# Product Change Notification

Date Issued :	May 19, 2023	PCN Number :	513631
Reason for Change :	Change to Product		
Description of Change :	This notification is to inform you about changes that are being made to the part(s) as identified in the list. This change will affect the Fit, Form, Function, or appearance of the parts. Or it may result in a change to the specification or raw material.		
Assessment of Change :	First Article Inspection		
Planned Implementation Date :	November 20, 2023		
Sample Availability Date:	October 13, 2023		
Internal Molex Qualification Date :	October 13, 2023		
Last date to request Samples by Customer :	October 13, 2023		
Traceability Code Markings / Date :	Date code

Before Picture

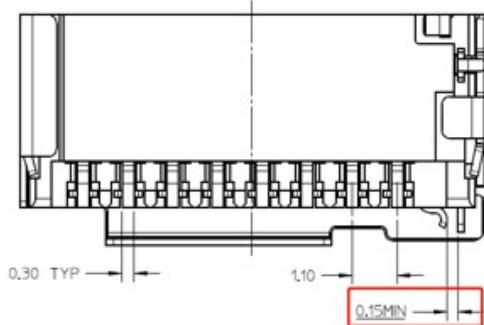
- Per simulated the tolerance analysis to optimize product tolerances

After Picture

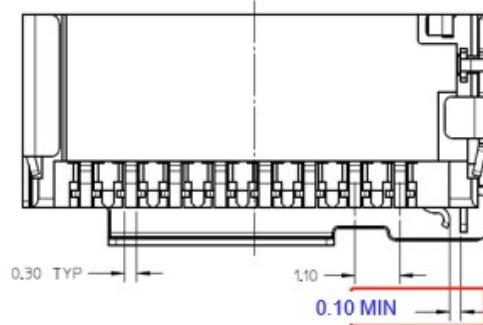
- Per simulated the tolerance analysis to optimize product tolerances
- Product Impact:  
No impact to fit, form or function.
- Part Number Impact:  
See attached impacted parts list
- Qualification Reports and samples available upon request after the date shown above
